**U.S. COMMISSION OF FINE ARTS  
CONCEPT REVIEW SUBMISSION**

**THE WHITE HOUSE VISITOR SCREENING  
FACILITY PROJECT**

EXECUTIVE OFFICE OF THE PRESIDENT/UNITED STATES  
SECRET SERVICE/ NATIONAL PARKS SERVICE

### 2.2 PROPOSED FACILITY - CFA COMMENTS FROM 03/19/2026 CONCEPT SUBMISSION

PLAN VIEW: PROPOSED LANDSCAPE PLAN

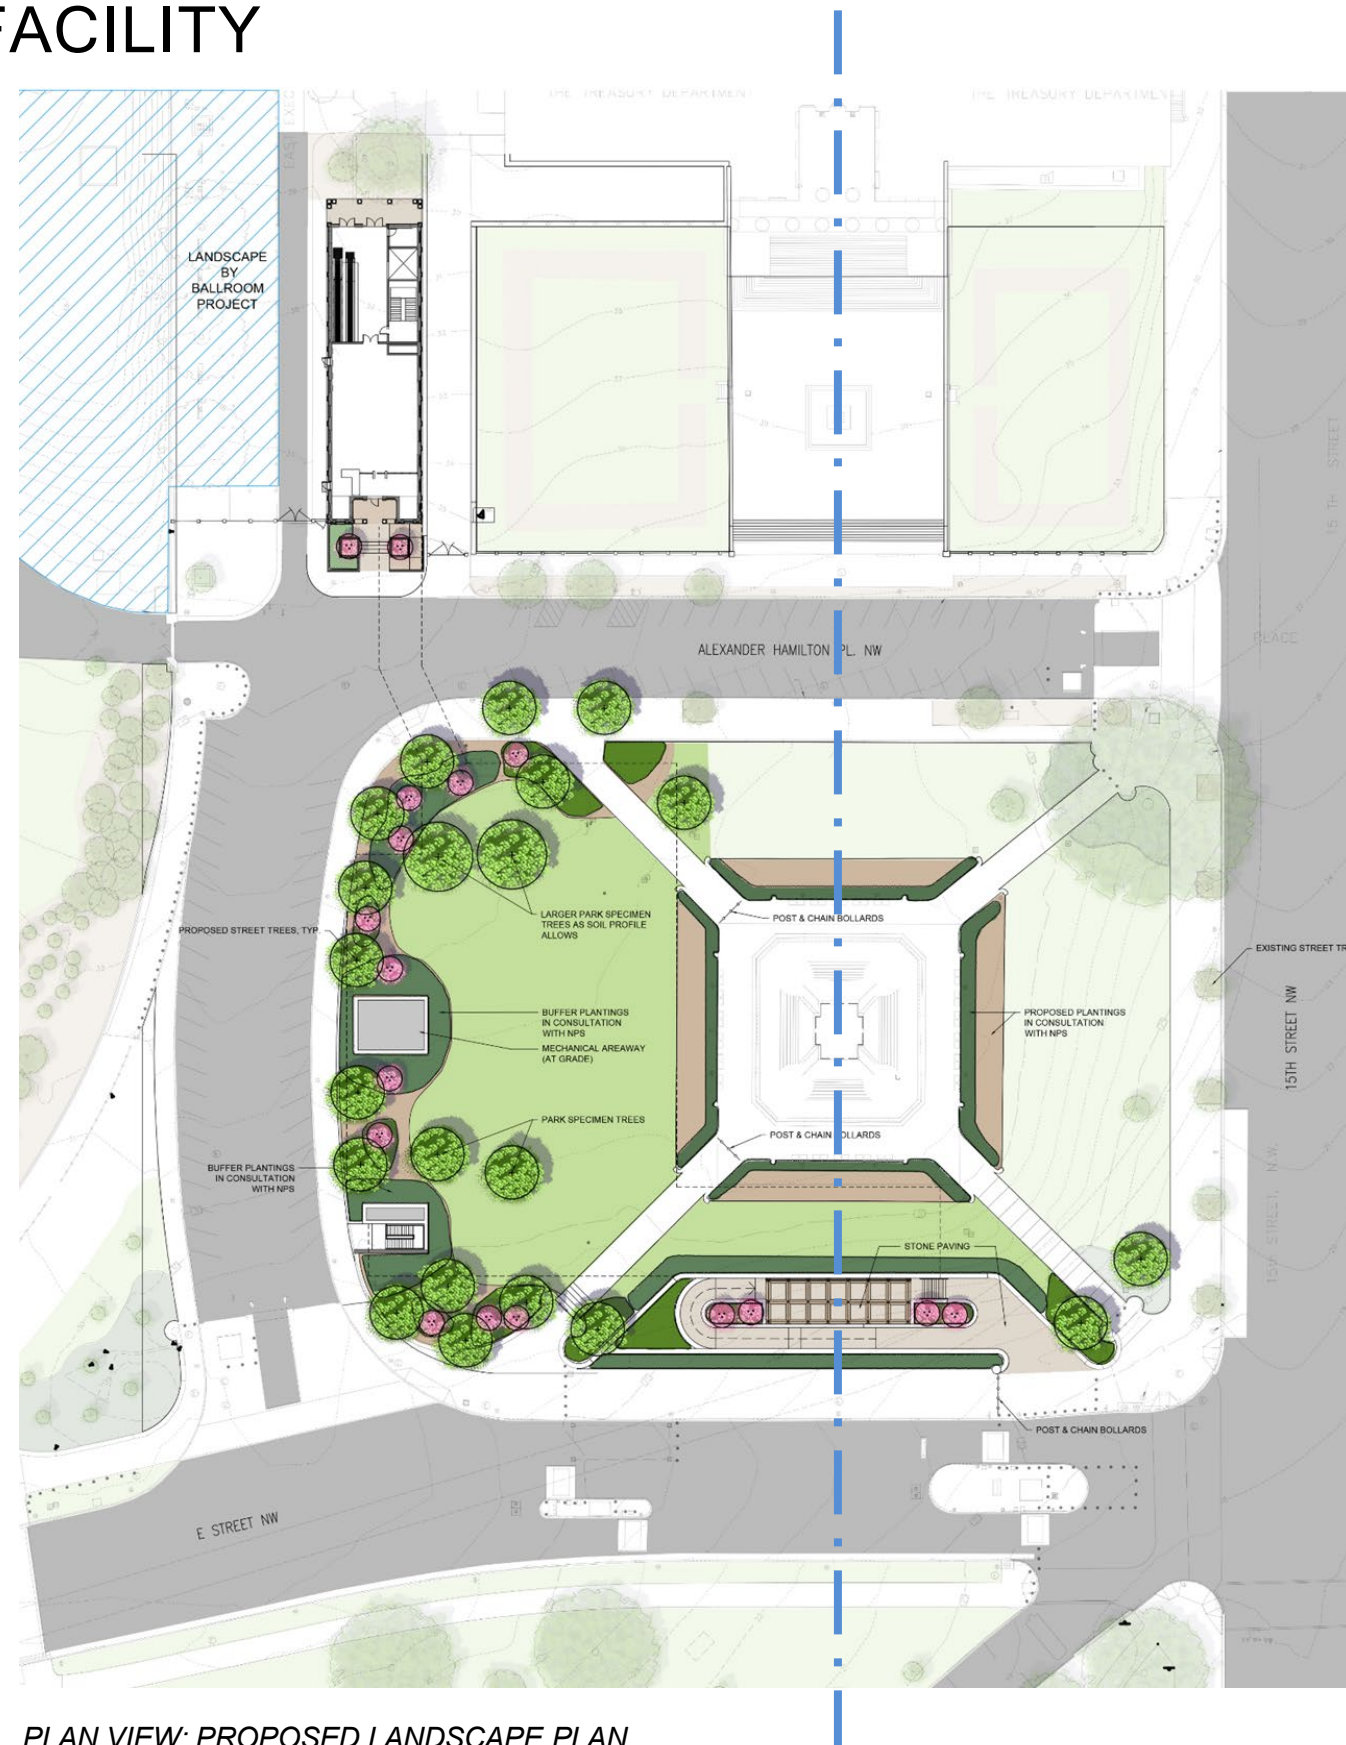
#### CFA Comment 3/19/2026 - Provide a landscape plan:

#### CFA Comment 3/19/2026 - Maintain historic landscaping and paving:

#### CFA Comment 3/19/2026 - Review alignment with Treasury Building and Sherman Monument:

- The proposed landscape plan identifies all new trees, plantings, and grass areas planned within the scope of this project. Plantings around existing and new site walls will be selected and coordinated with NPS to provide a cohesive design that includes all 4 sides of the monument.
- The landscape design for the west side of East Executive Avenue across from the proposed exit building (location of existing temporary trailers) will be provided as part of the adjacent East Wing project.

- The existing historic pathways and retaining walls at each corner of the park will remain in the finished site condition, however, the northwest and southwest pathways will need to be removed and rebuilt to accommodate construction of the proposed facility below.
- Steps will be integrated into the rebuilt southwest pathway to clear the proposed structure below.
- The retaining walls framing the new plaza align with the existing curved corners on either side of the park's south quadrant. Where the side walls meet the primary south-facing entry wall, they maintain eased angles consistent with the historic site walls at the base of the monument.

- The proposed recessed plaza retaining walls and main entrance doors have been shifted east to align on axis with the Treasury Building and Sherman Monument.

RENDERING SHOWS VIEW OF FACILITY ENTRANCE RAMP AT E STREET AND 15<sup>TH</sup> STREET ADJACENT TO SHERMAN PARK

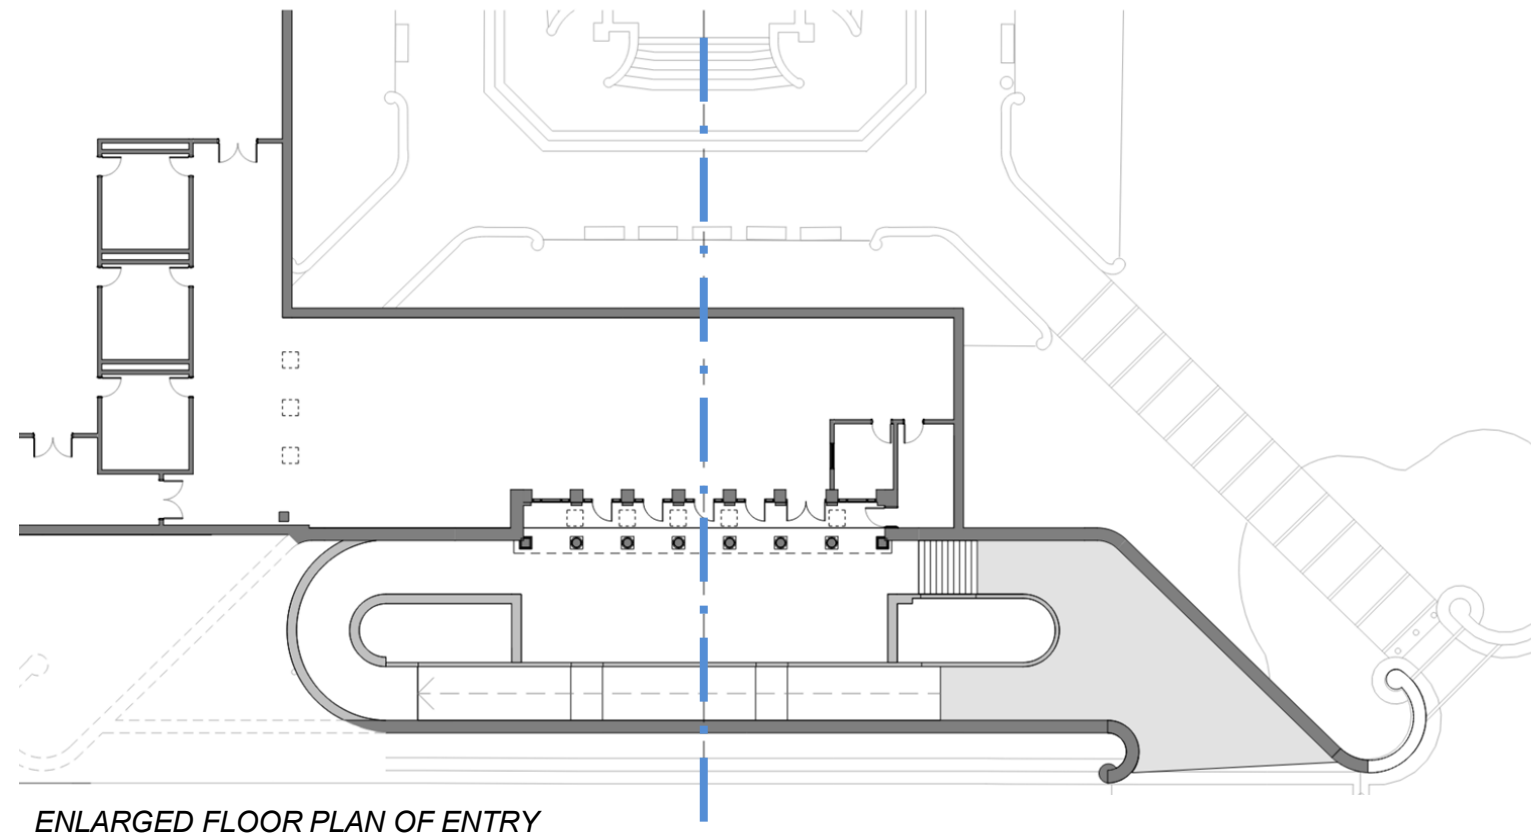
CFA Comment 3/19/2026 -

Review design to incorporate Executive Order on Architecture

- Designed with a classical influence and aligned symmetrically on axis with the Sherman Monument and Treasury Building.
- 8 columns with entablature above - shown in Doric style to relate to the scale and prominence of surrounding buildings.
- Entry doors are set back with pilasters between doors to align with the colonnade.

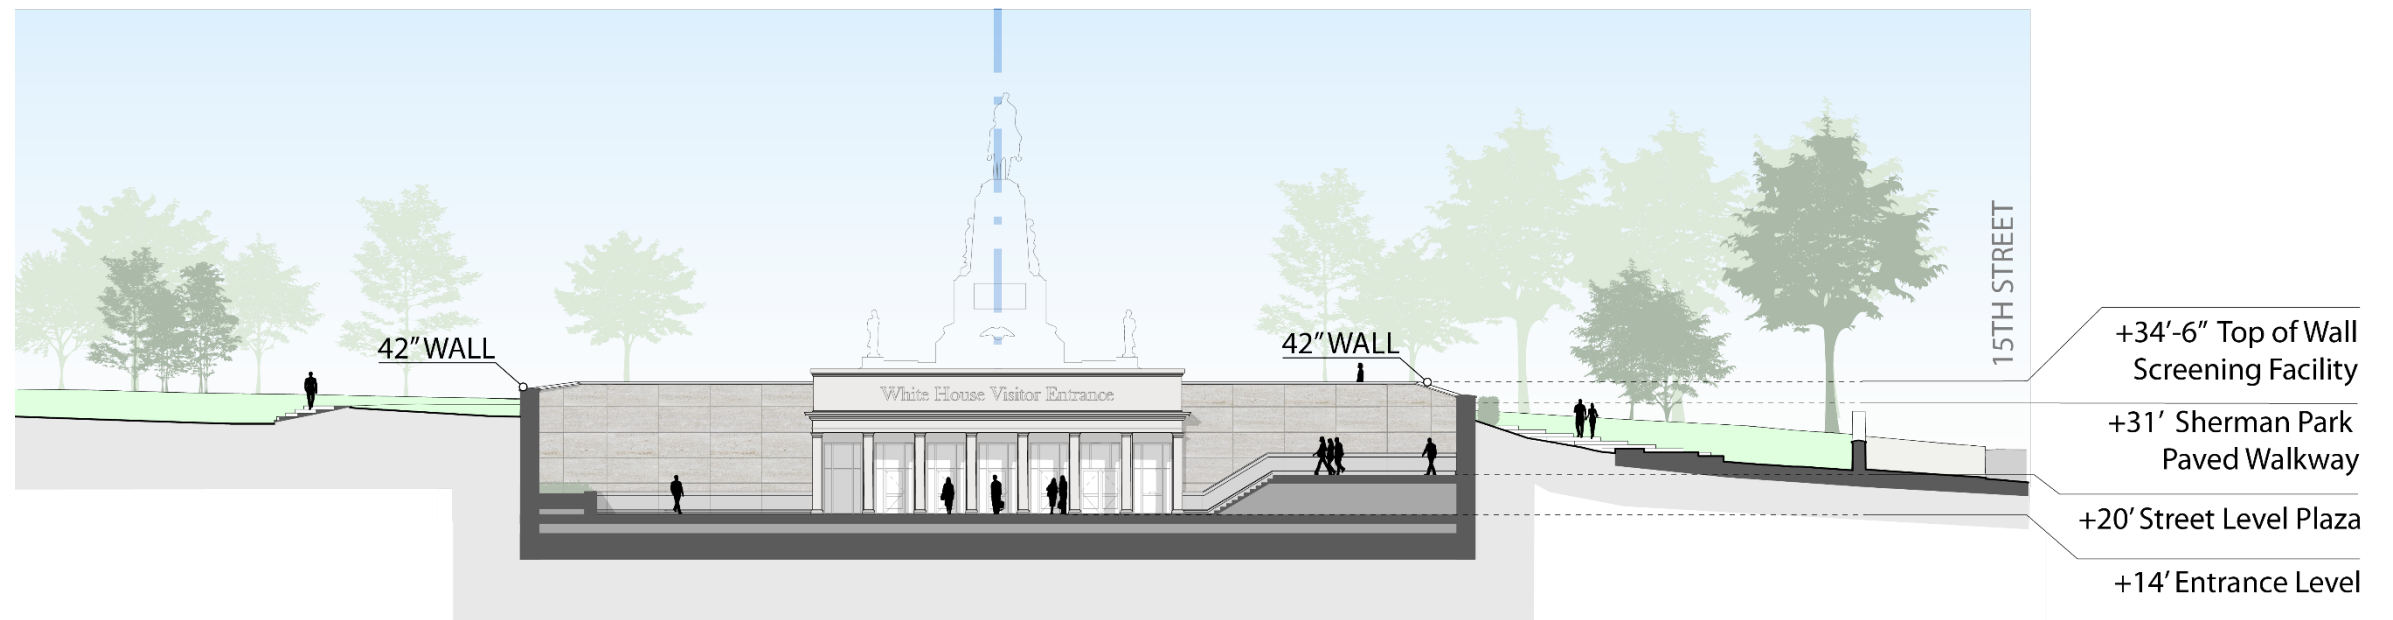
CFA Comment 3/19/2026 - Review alignment with Treasury Building and Sherman Monument:

CFA Comment 3/19/2026 - Review entrance design for potential artwork, etchings, or public art

- The proposed recessed plaza retaining walls and main entrance doors have been shifted east to align on axis with the Treasury Building and Sherman Monument.

- Proposing a refinement to the retaining walls that visually reduces their scale through the introduction of banding and granite texture, reinforcing human scale while preserving material purity.

SECTIONS SHOWING VIEWS THROUGH THE FACILITY UNDERNEATH SHERMAN PARK

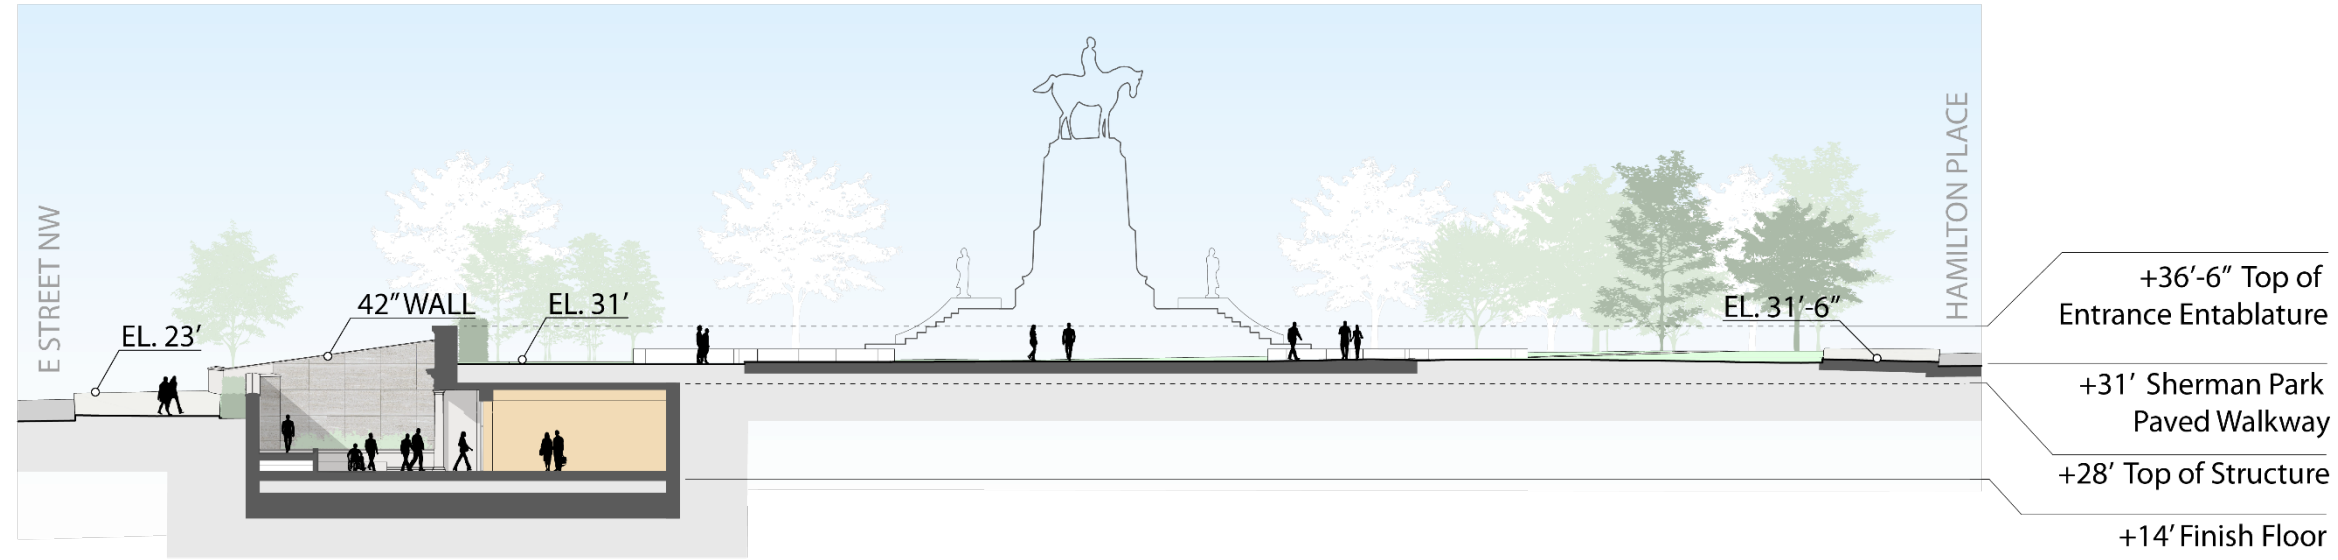
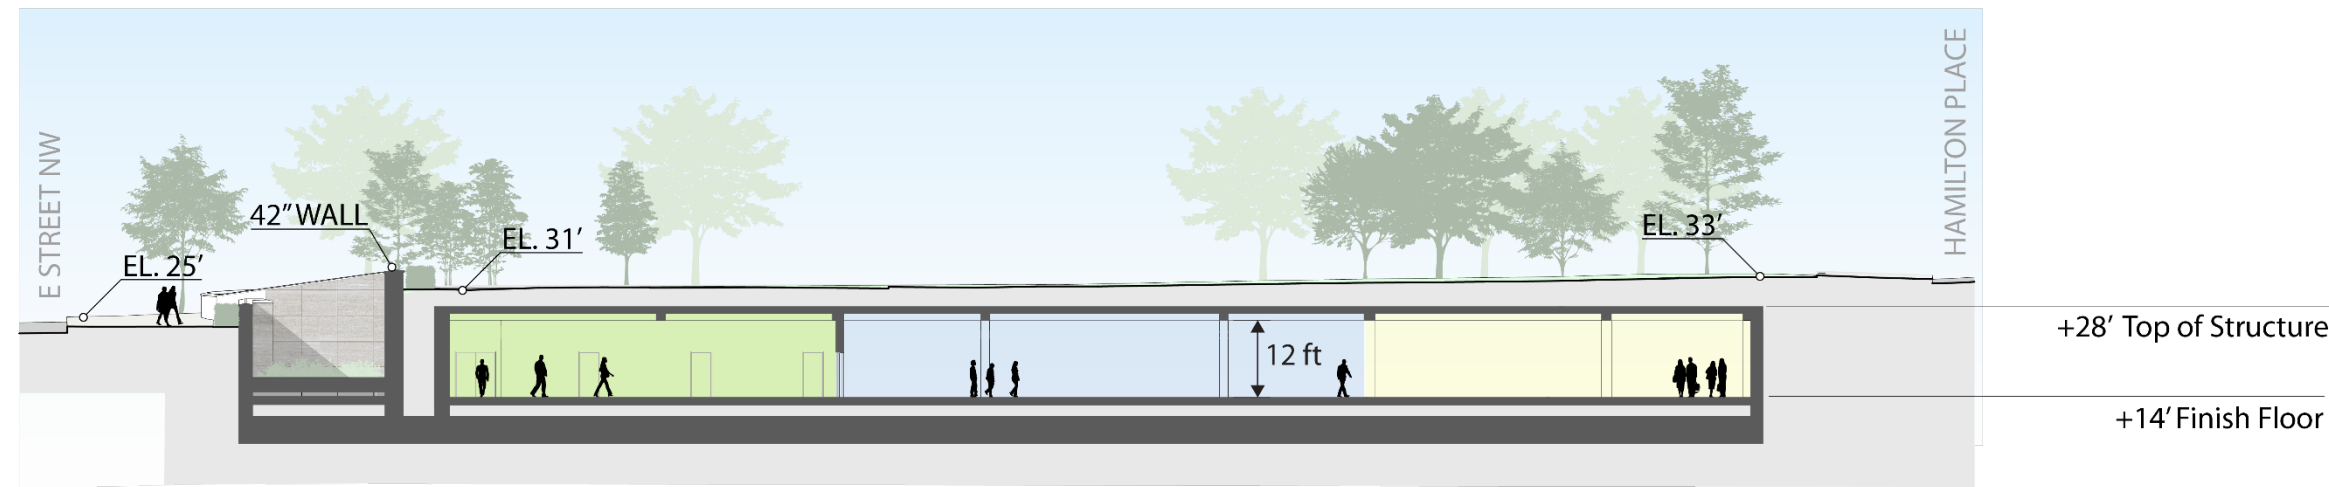
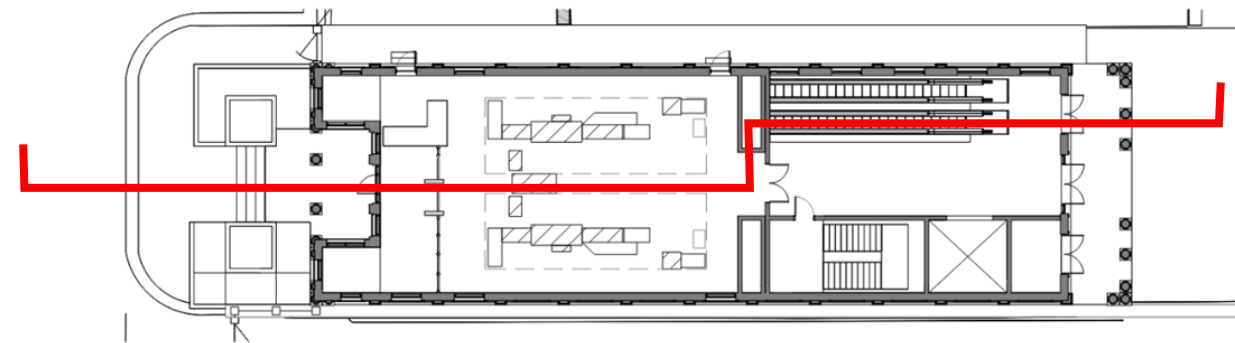
CFA Comment 3/19/2026 -  
Reduce retaining wall heights :

- Retaining walls match existing heights where possible or set at 42" above finished grade with landscaping adjacent.
- To reduce the prominence of walls within the plaza - ramps and stair walls will remain low with ornate guardrails and handrails where required.

SECTION SHOWING VIEW THROUGH ABOVE-GRADE SCREENING AND CLEARED VISITOR EGRESS

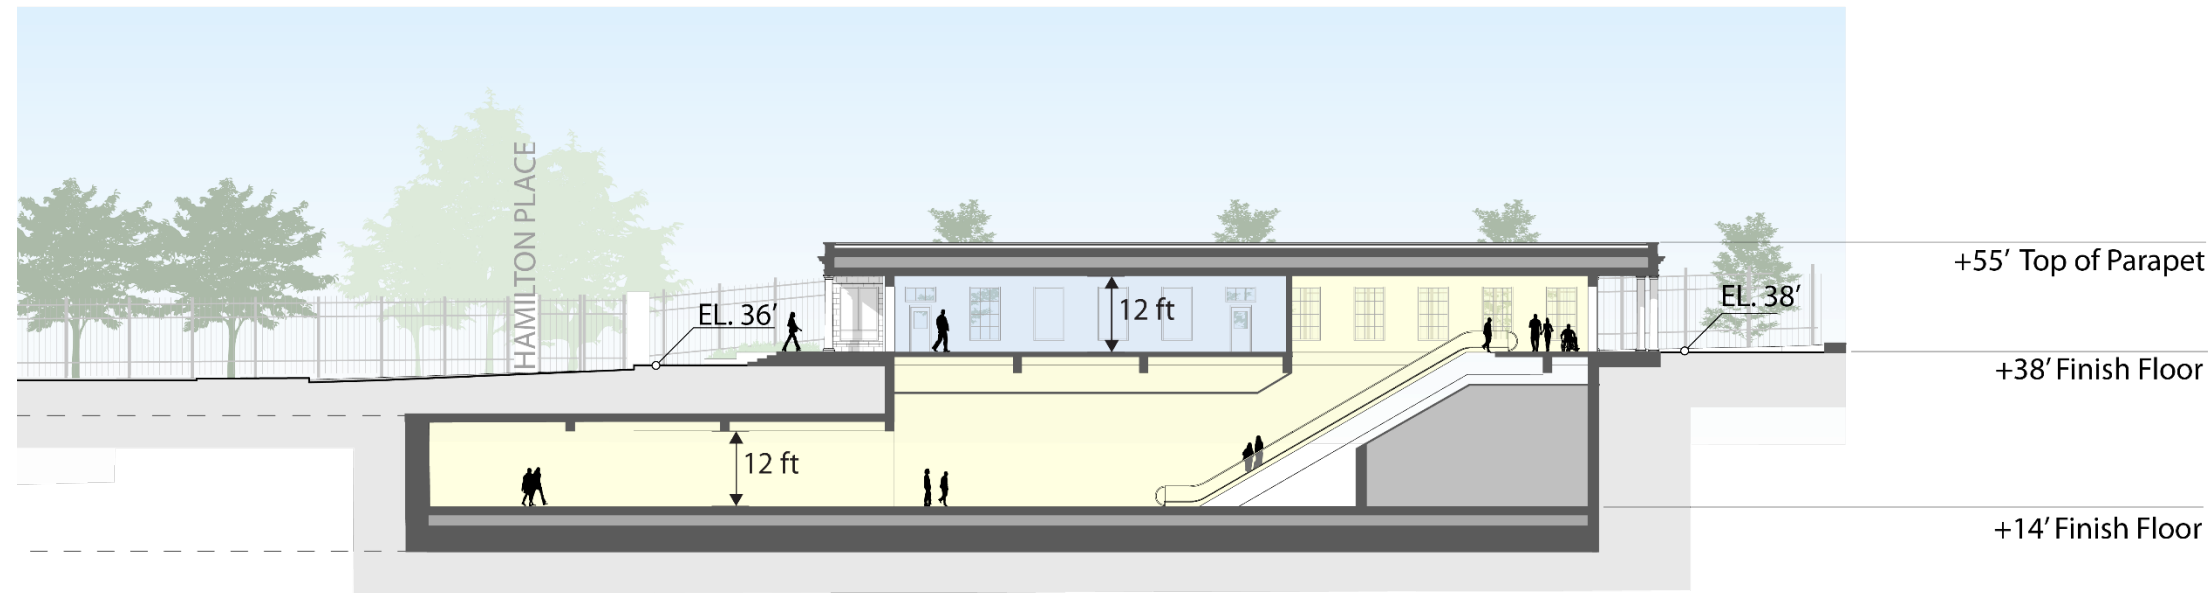
CFA Comment 3/19/2026 -  
Reduce size of exit building:

- Flattened roof and reduced overall height of parapet to 17'-0" to accommodate the minimum height needed for 12'-0" clear at screening equipment and 13'-10" elevator overrun.
- Overall building length is being reviewed and will be reduced if security screening equipment requirements are met.
- Evaluated with civil design to locate building at finished floor elevation 36'-0". Adjacent road contours pose many challenges. The building as designed is shown at 38'-0" FFE with an integrated granite base, steps, and ramp.
